**ADDENDUM NO. 2**  
to the  
**Bid Documents**  
for  
**DPW Project #24253**  
**UI Nez Perce Drive Improvements**  
**Moscow, Idaho**

**February 5, 2026**

DRAWN:  CHECK:   
VERIFY SCALE: Scales  
based on 22" x 34" prints.  
1-1/2 Inches  
PROJECT NO. 208106-116  
PAGE  
SHEET NO.  
**LIGHTS 1**

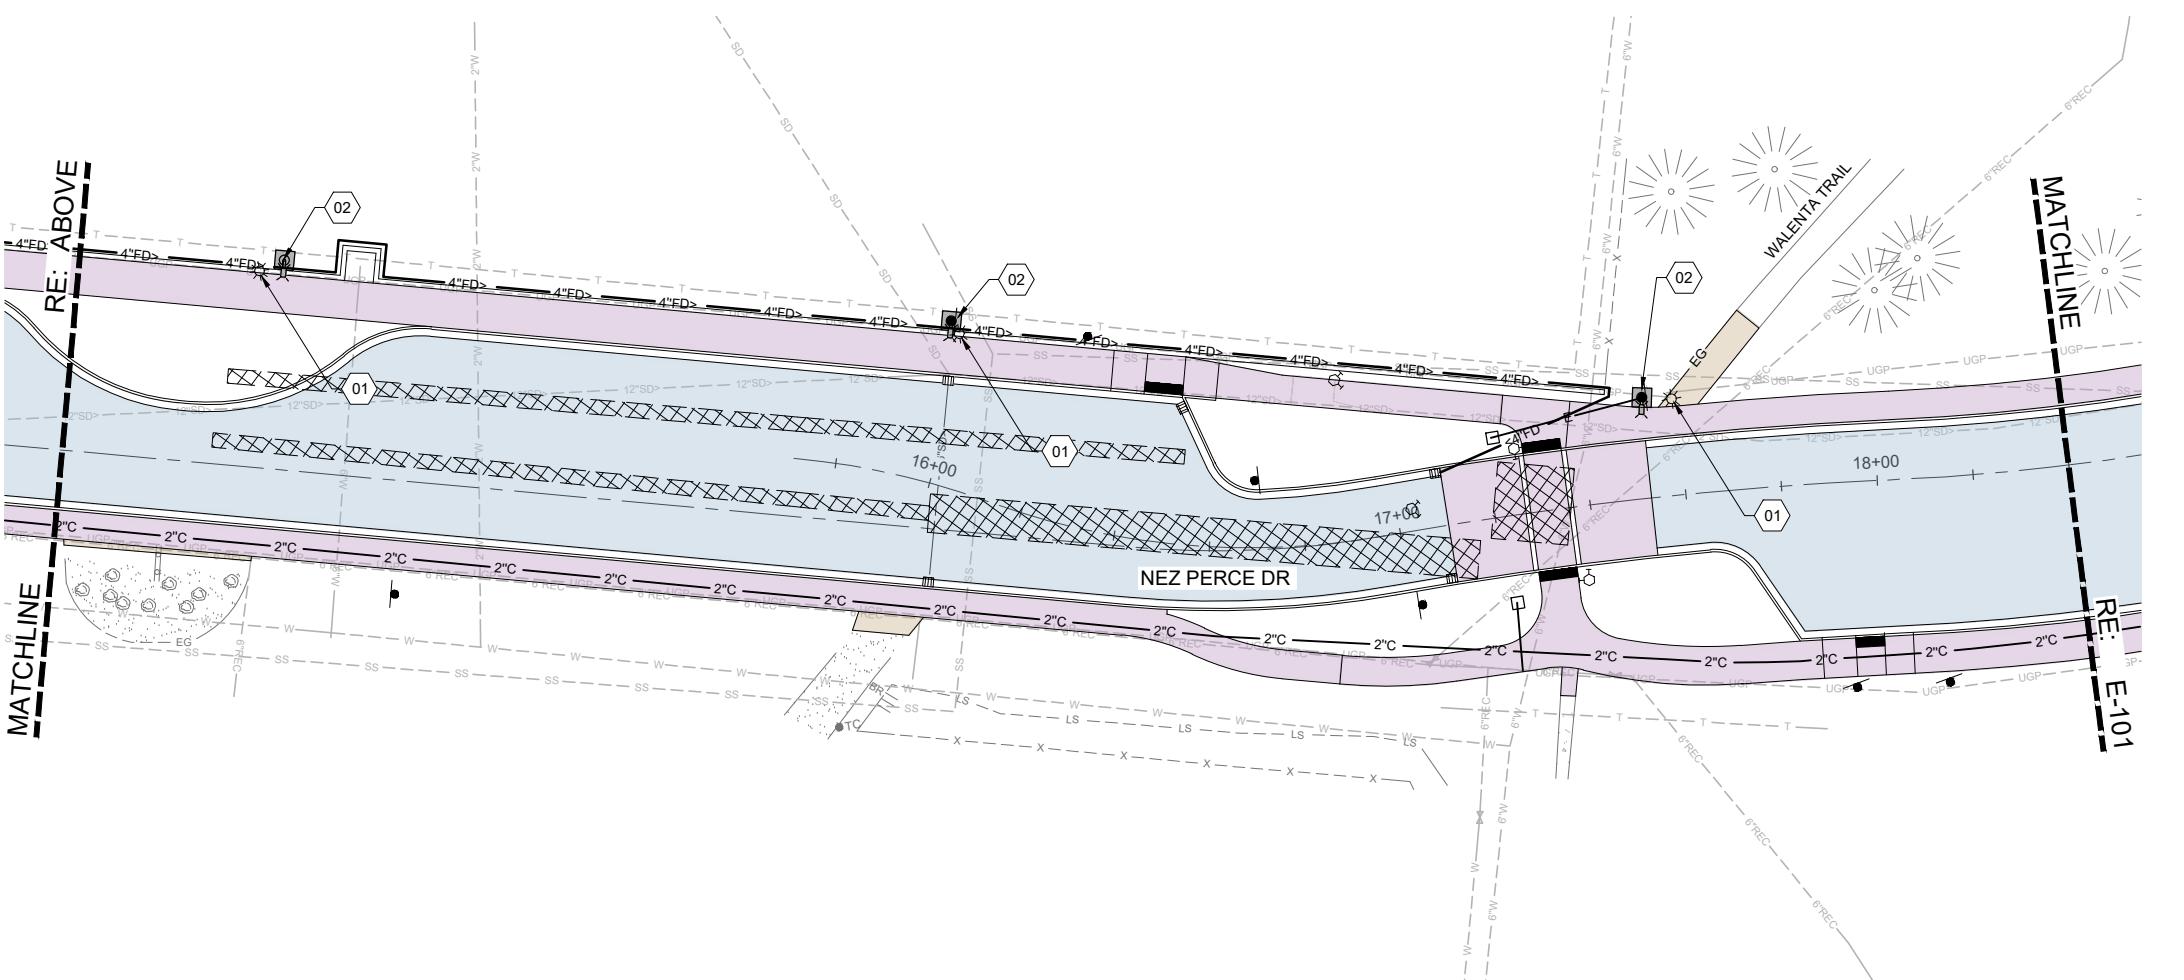
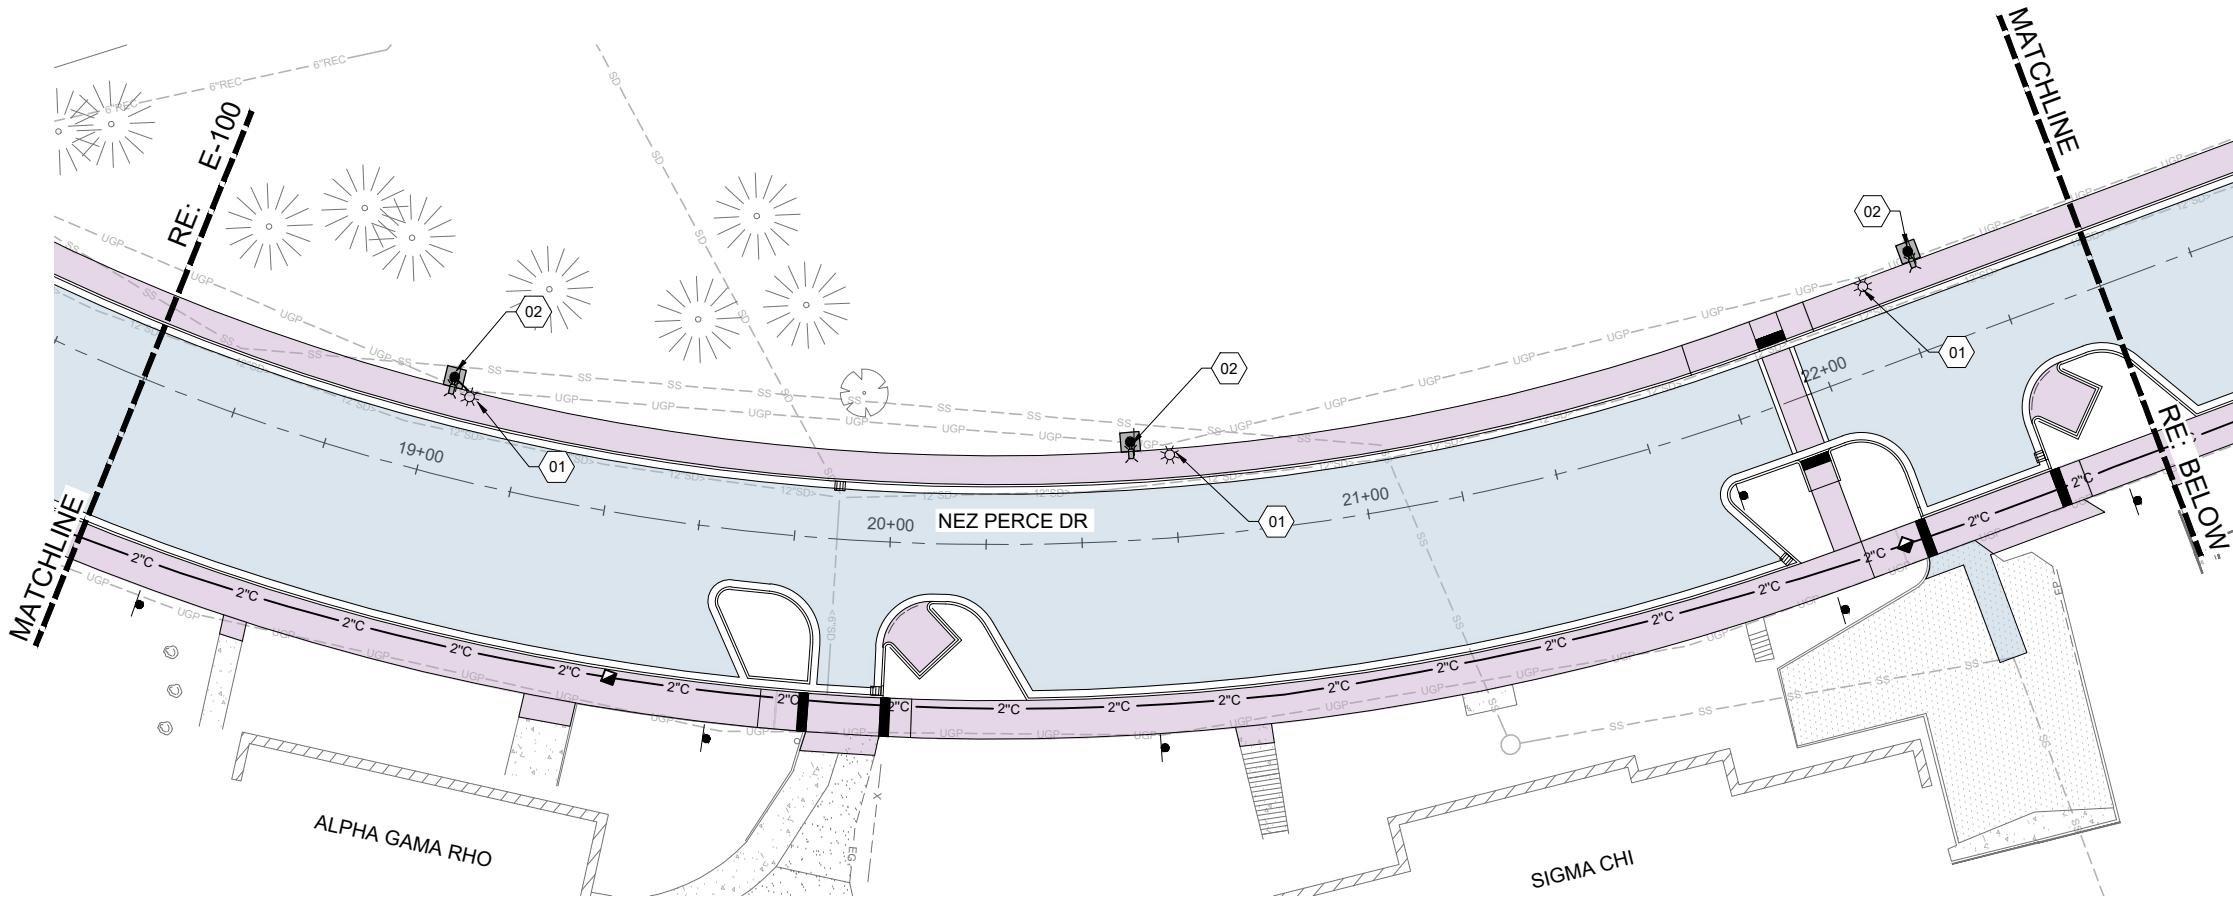
**Question #2:** Will the existing versus proposed light locations be shared to clarify the distance that the lights are moving?

**Answer #2:** *Keller will provide an exhibit showing the light locations for both proposed and existing locates (see attached exhibit).*
